August 20, 2012

**SUBJECT: Comment Letter: Draft Policy for Toxicity Assessment and Control**

### CLEAN WATER ASSOCIATION TECHNICAL COMMENTS PROPOSED POLICY FOR TOXICITY ASSESSMENT AND CONTROL

**Figure 1.** Fathead minnow survival effects between 0% and 25%. All tests conducted by the Districts San Jose Creek Water Quality Laboratory in 2009.

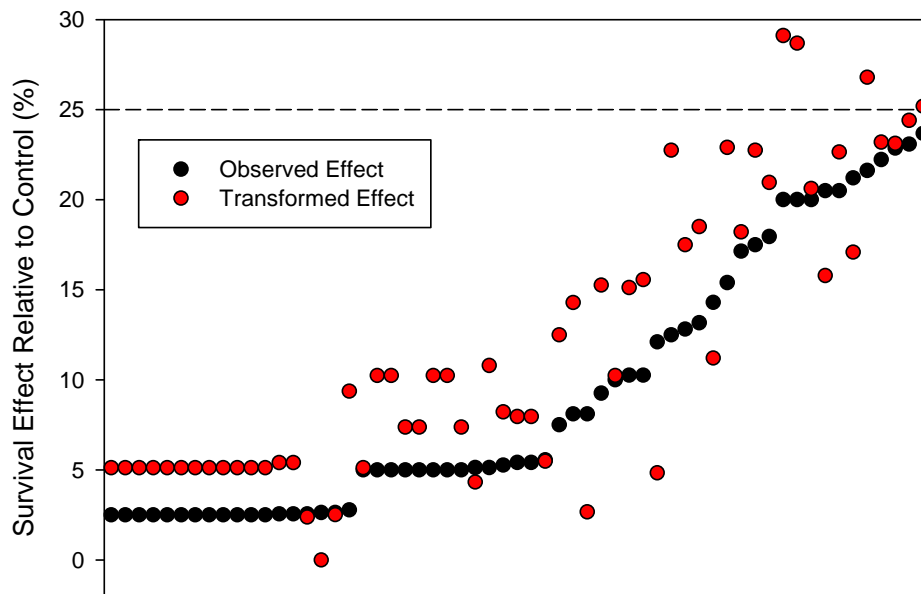
Transforming percentage data (e.g., survival responses) is a commonly accepted practice prior to conducting hypothesis testing where normal distribution assumptions are critical in the statistical analysis. When using the commonly applied arc-sine transformation, a bias resulting in the calculated response or effect using the transformed data is typically greater than the actual observed response of effect. This bias poses little concern when traditional hypothesis testing is conducted because all transformed treatments are compared directly to the transformed control. However, with the TST hypothesis test, the transformed treatments are compared to 75% of the transformed control. By not similarly transforming the binomial “b” or bioequivalency factor (75% for chronic tests and 80% for acute tests), this bias will significantly increase the probability of identifying a sample as toxic. The effect and magnitude of this bias in real world samples exhibiting observed effects ranging from zero (0) to 25% are presented in Figure 2.

a. All Calculated Effects Should Be Determined Using Untransformed Data.

The fathead minnow survival data example contained on page 22 of the Revised Draft Policy calculates the percent effect in the instream waste concentration (IWC) using arc-sine transformed survival data as represented below:

After reviewing the EPA's TST spreadsheet tool (version 1.5), it is clear that all effects are to be calculated using original, not transformed data. Considering that there is significant positive bias associated with calculating percent effects at the IWC using transformed data, EPA TST tools calculate percent effects using untransformed data, and that accurate calculations of these estimates are critical for reasonable potential determination, MDEL evaluation, and TRE trigger determination, all references and examples in the Revised Draft Policy should clearly indicate that original units are to be used for these calculations.
